SUBJECT: **Item 5—Detailed Site Plan DSP-22023 Greenbelt Square**
Planning Board Agenda May 18, 2023 – Staff Revisions to Applicant's Proposed
Conditions

DSP-22023

SUBJECT: Detailed Site Plan DSP-22023
Type 2 Tree Conservation Plan TCP2-009-2023
Greenbelt Square

Community Steel Waste Receptacles

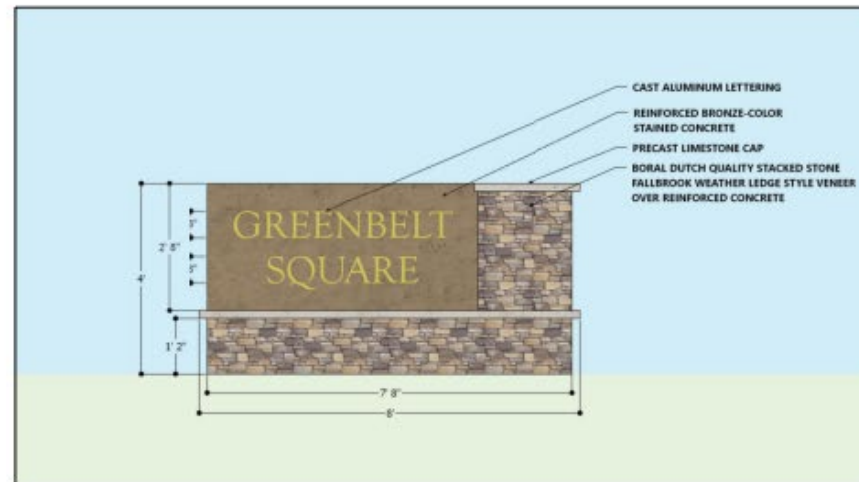
- w. **Provide dog waste stations in locations approved by the Urban Design Section and the City of Greenbelt.**
- x. **Revise waste receptacle detail on Sheet 5 of the DSP to show Dumor Site Furnishings Receptacle 158, PT dome top with self-closing door and steel shield or one of comparable design. Where waste receptacles are shown, provide recycling receptacles as well reflecting the same design as waste receptacles.**

5. Provide dog waste stations in logical areas on the site.
6. Revise waste receptacle detail on Sheet 5 of the DSP to show *Dumor Site Furnishings Receptacle 158, PT Dome Top with Self-Closing Door and Steel Shield* or one of comparable design. Where waste receptacles are shown, provide recycling receptacles as well reflecting the same design as the waste receptacles.

MONUMENT SIGN

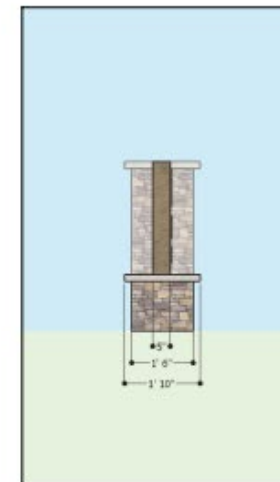
- z. **Revise the monument sign detail shown on Sheet 5 to reflect a new art deco sign design as supported by the City of Greenbelt and consider rounding the upper**

9. Revise the TCP II plan to show two tree save areas along the MD 193 frontage.
10. Revise the monument sign detail shown on Sheet 5 to reflect the new sign design proposed as shown on Attachment A, and consider rounding the upper corners of the sign. Provide landscape plan to the City for review at time of the sign permit application.
